**DOCUMENT 00 90 00**  
**ADDENDUM**

**ADDENDUM No.:** 1

**DATE:** October 19, 2023

**RE:** LHA 2023 CAPITAL IMPROVEMENTS  
MULTIPLE LOCATIONS – SEE DRAWINGS  
LA CROSSE, WI  
PROJECT NO. 23037

4 2-9TH REMODELED PLAN  
1/8" = 1'-0"

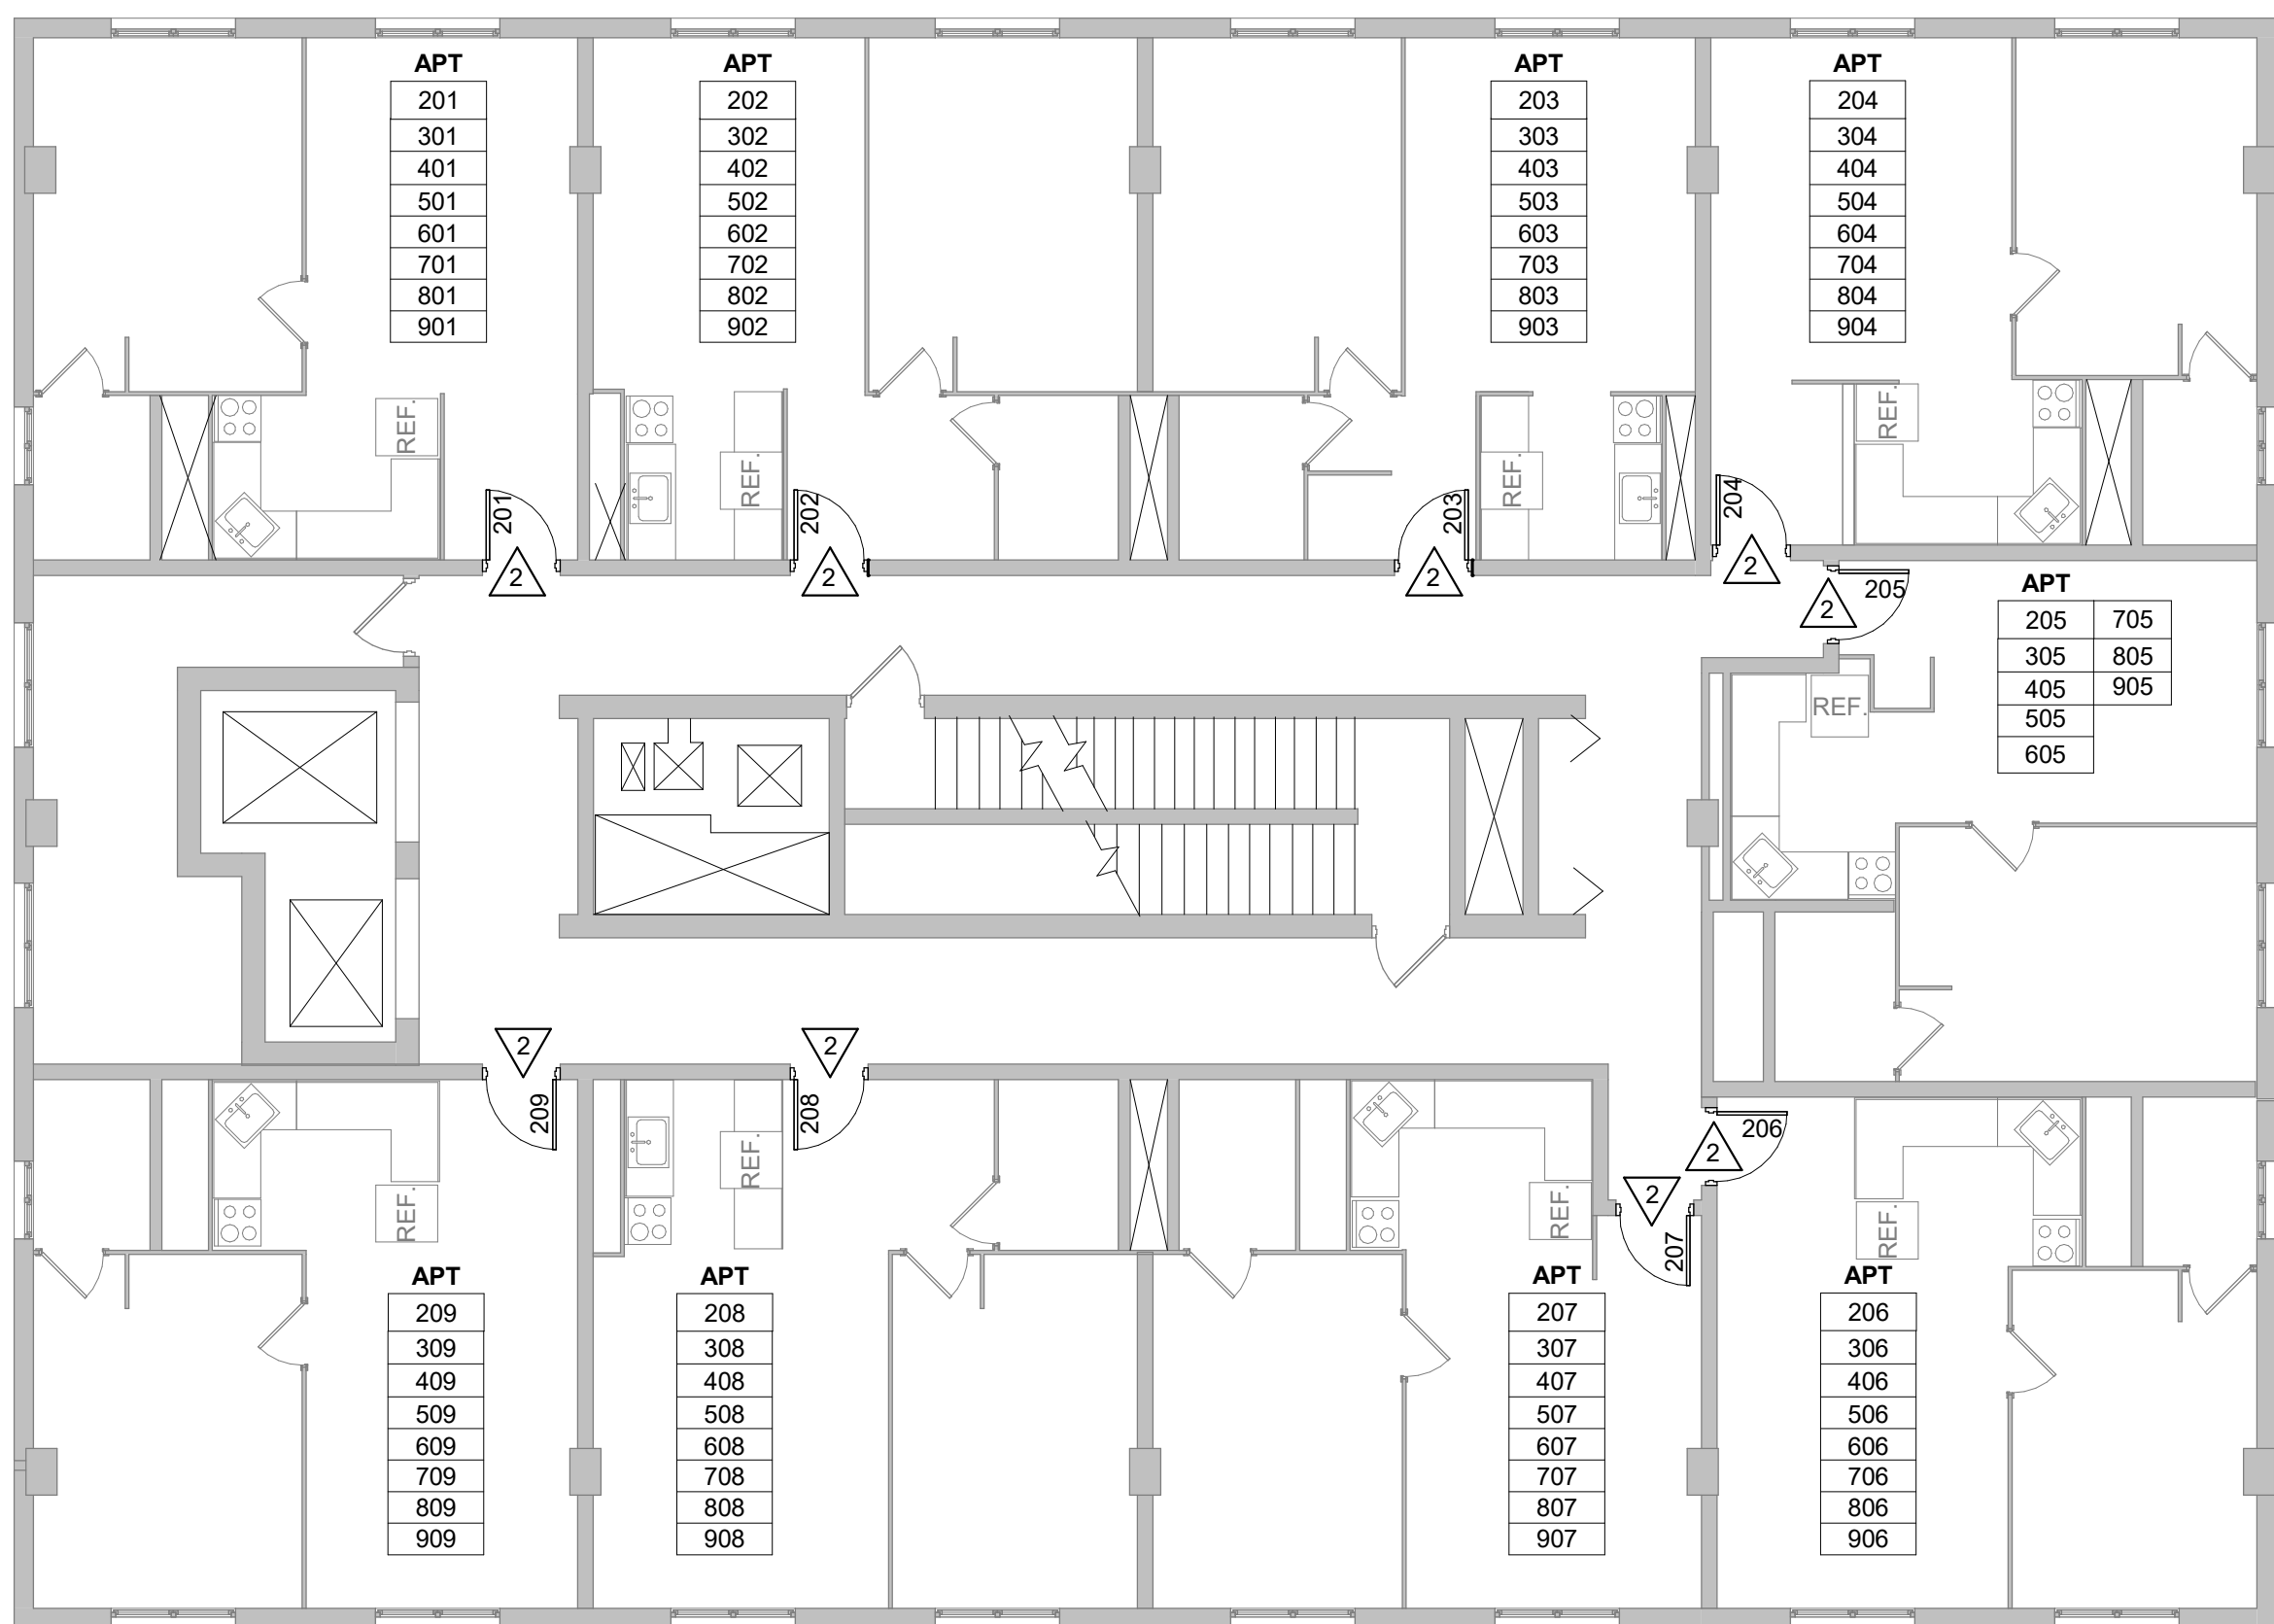
7. Sheet A100 FIRST FLOOR (STOFFEL COURT) 30"x42"
  - a. See the revised sheet included in this addendum. Disregard the previous version.
  - b. Added photos and dimensional information for door frames and hardware.

- c. Revised the door schedule.
8. Sheet A200 FLOOR PLANS (BECKER PLAZA) 30"x42"
  - a. See the revised sheet included in this addendum. Disregard the previous version.

MODIFY STRIKE FOR NEW HARDWARE. REMOVE GROUT AT STRIKE LOCATION FOR CLEARANCE OF NEW DEADBOLT. PATCH & PAINT FRAME AT LOCATION OF MODIFICATIONS TO MATCH EXISTING.

1 REMOVE EXISTING DOOR SLAB - PREPARE OPENING AS REQUIRED FOR NEW DOOR SLAB - SEE DOOR SCHEDULE.

2 INSTALL NEW DOOR SLAB IN EXISTING FRAME - MODIFY FRAME AND STRIKE AS REQUIRED FOR NEW DOOR HARDWARE. PAINT AND FILL FRAME MODIFICATION FOR CONSISTANT FINISH - SEE SPEC

3rd, 4th, 5th, 6th FLOOR PLANS

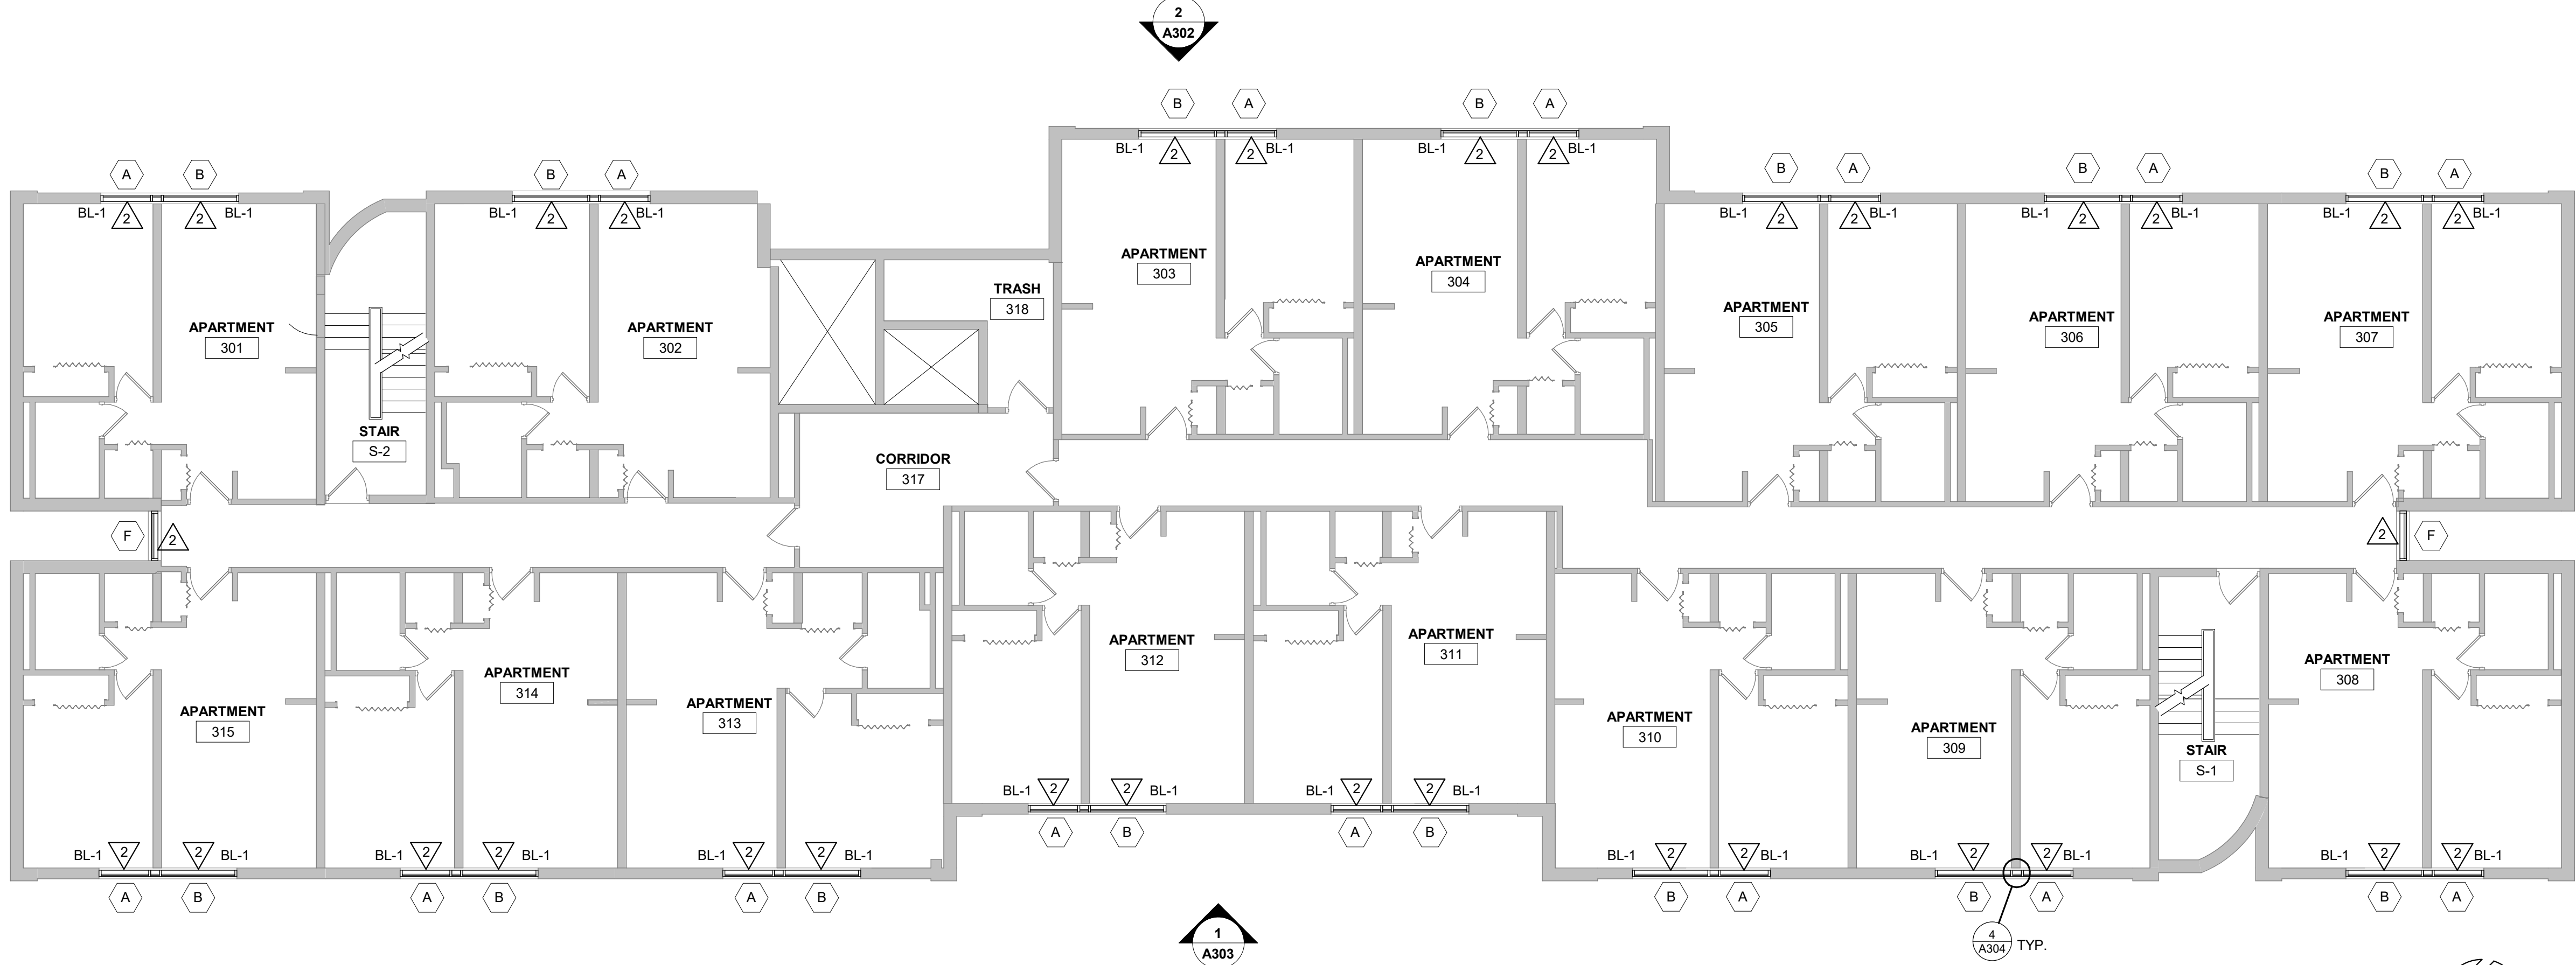
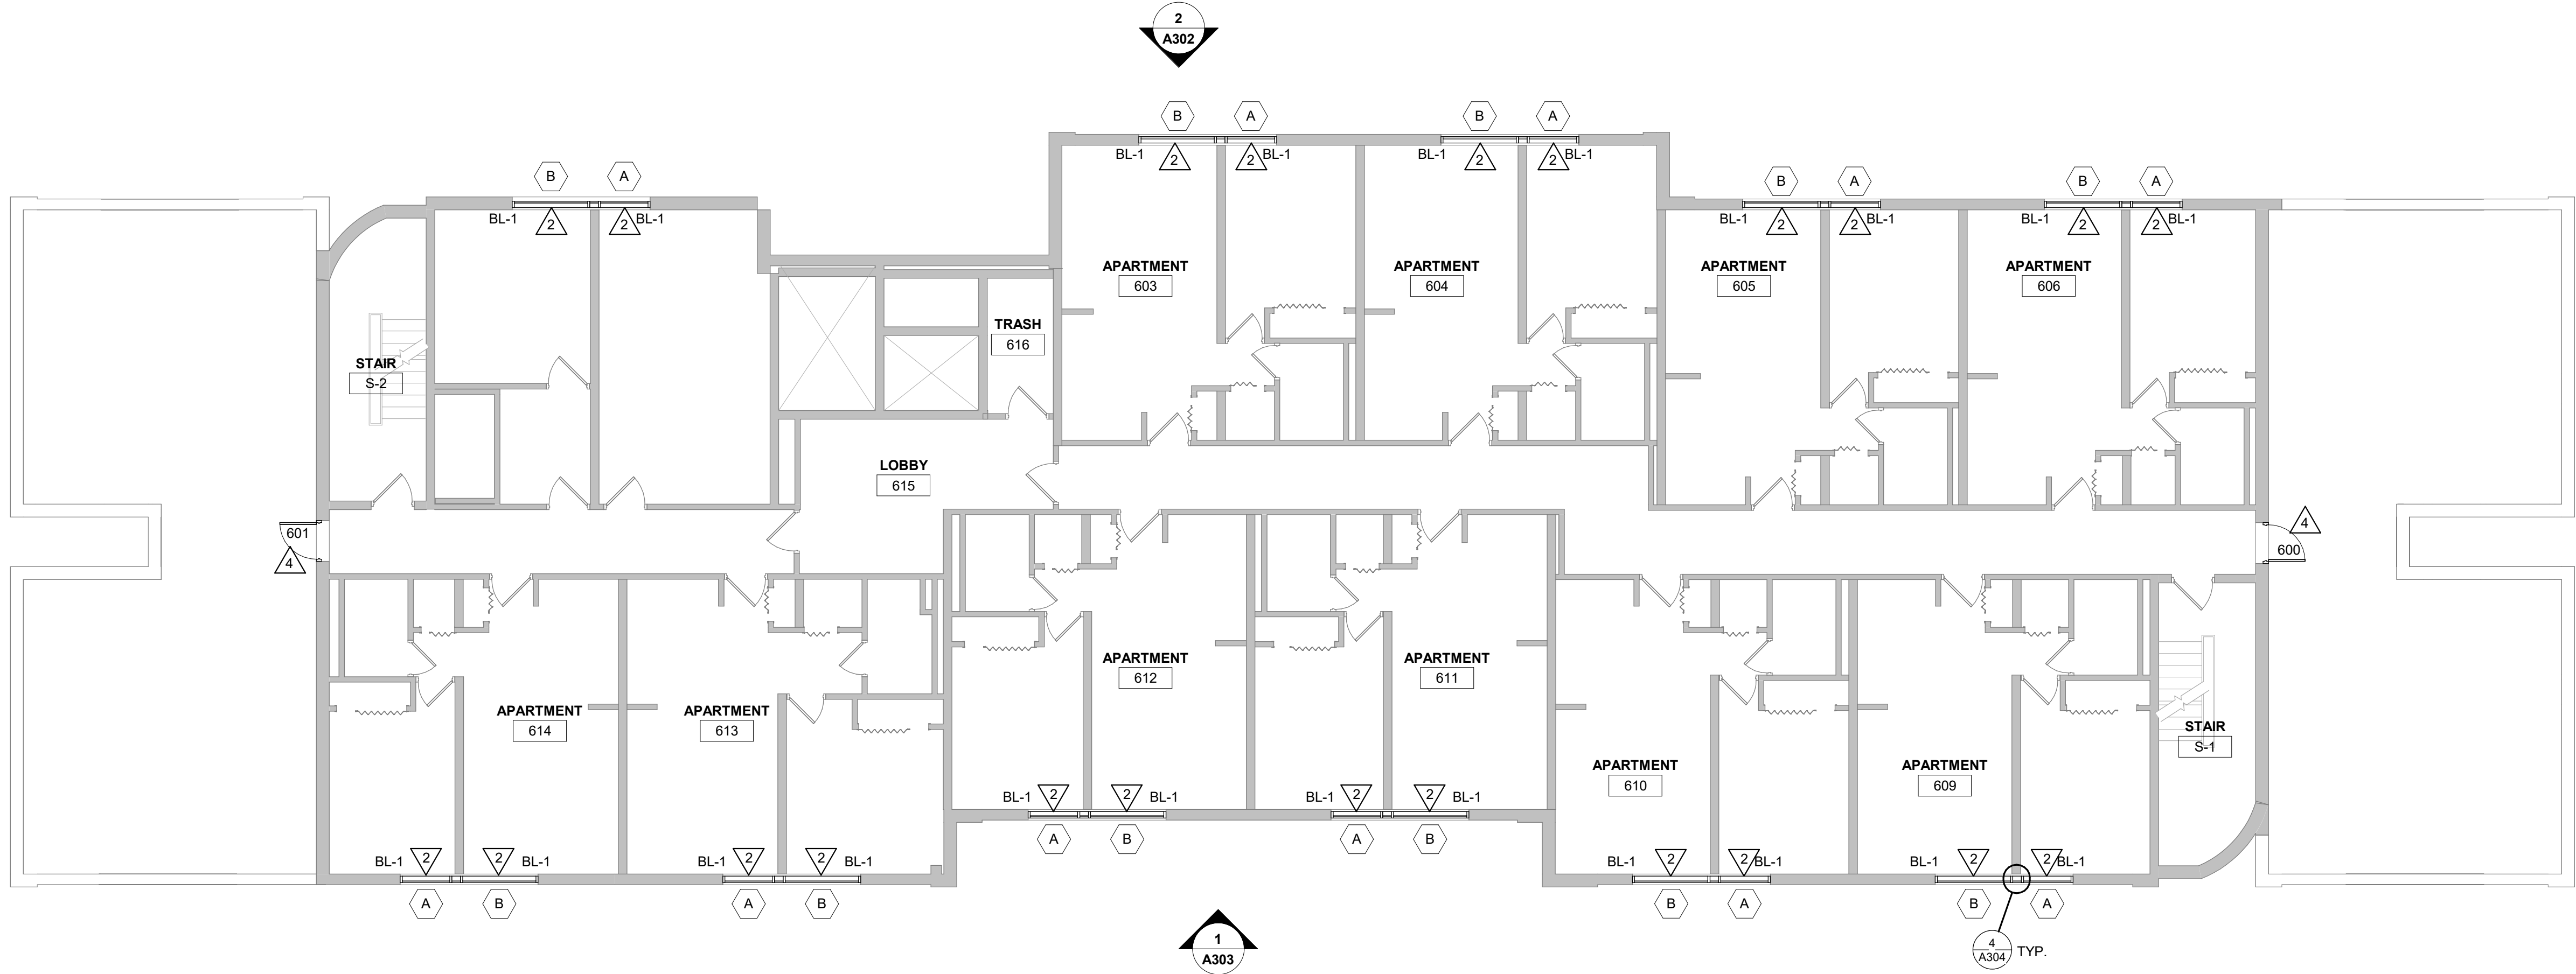
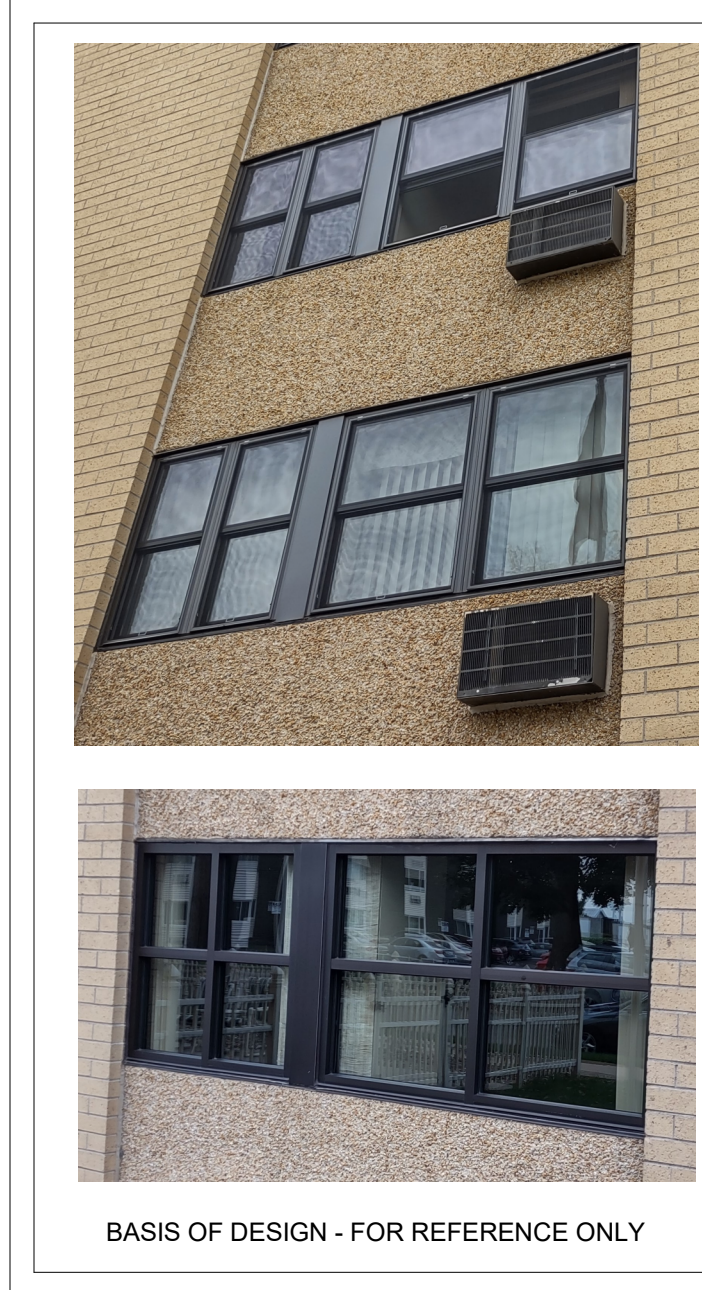
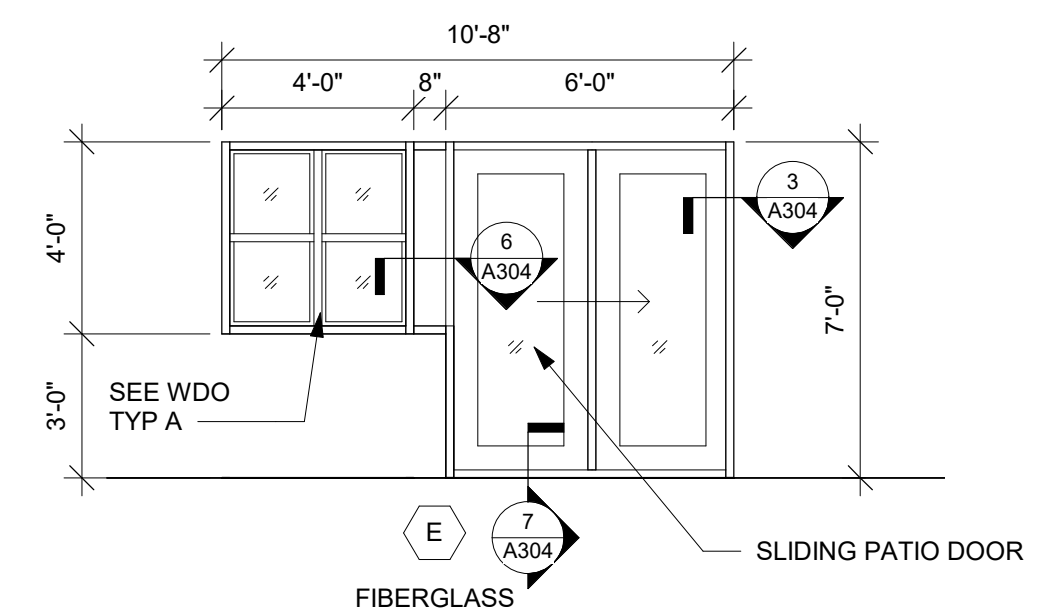
- b. Identified doors and added door schedule.
9. Sheet A301 3RD, 4TH, 5TH, 6TH, FLOOR PLANS (SOLBERG HEIGHTS) 30"x42"
  - a. See the revised sheet included in this addendum. Disregard the previous version.

- b. Removed photo of access door. Added photos of windows.
10. Sheet A303 FRAME ELEV., & DOOR SCHEDULE (SOLBERG HEIGHTS) 30"x42"
  - a. See the revised sheet included in this addendum. Disregard the previous version.

Sheet Title:  
SITE PLAN & DETAILS

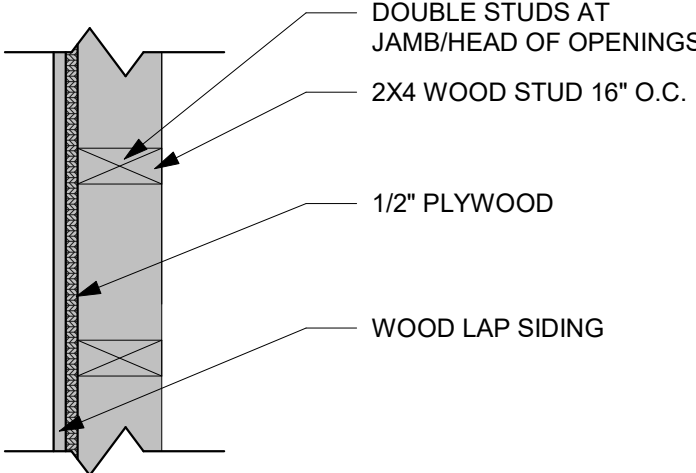
- b. Revised door schedule.
11. Sheet A400 SITE PLAN & DETAILS 30"x42"
  - a. See the revised sheet included in this addendum. Disregard the previous version.

- b. Revised Key Note #1 to correct door size.

KEY NOTES PLAN	
1	REPLACE EXISTING HM SHED DOOR, WITH NEW 3'-0" x 6'-8" HM DOOR AND FRAME.

- REMOVE AND SALVAGE EXISTING LAP SIDING AS REQUIRED FOR NEW FRAME INSTALLATION.
- INSTALL NEW DRIP EDGE.
- SALVAGE EXISTING DEADBOLT/CORE FOR REINSTALLATION INTO NEW DOOR.
- PROVIDE NEW DOOR PULL.
- HM DOOR, PAINT TO MATCH EXISTING ADJACENT FINISH.
- WEATHER STRIPPING.
